Re: Submission to the Essential Services Commission regarding the North East Water (NEW) Price Submission 2026-2031 in both the Tallangatta and Kiewa - Tangambalanga Service Areas

Further to our review of the NEW Price Submission 2026-2031, we provide an overview of the current growth situation in Tallangatta and follow up with questions relative to the current submission.

TALLANGATTA GROWTH SERVICING PLAN

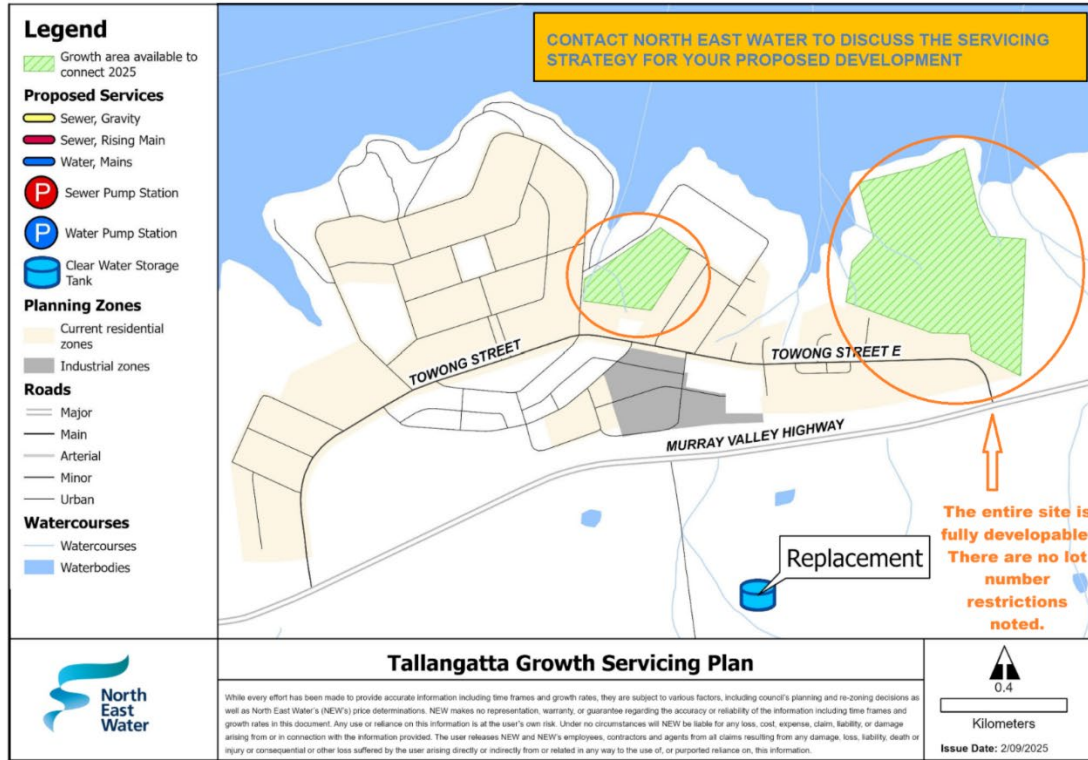
The above extract is included in the NEW's Growth Servicing Plan, attached to the Price Submission. It shows the areas within Tallangatta that are able to be developed. There are no noted restrictions, as is the case in other service areas such as Bright, Kiewa-Tangambalanga and Rutherglen – comments shown below. However, in order for the noted areas to be developed (more specifically the Towong Street E site) the sewer rising main network augmentation works shown in the above Sewer Network Option 3 plan must be constructed by 2028, in line with the NEW commissioned Stantec's report.

5. Why does the Price Submission include a Growth Servicing Plan that states the development parcel on Towong Street East is fully serviceable by 2025, when no explicit capital allocation has been made for Tallangatta wastewater augmentation works and NEW has separately confirmed that only 29 lots can be serviced without augmentation?

6. Why does the 2026–2031 Price Submission contain no explicit capital allocation for the Tallangatta wastewater augmentation works, specifically the 2.6km sewer rising main (SRM) noted in the Tallangatta Sewer Network above? The 2028 augmentation works must be included in the price submission for the Growth Servicing Plan to be accurate and reliable.
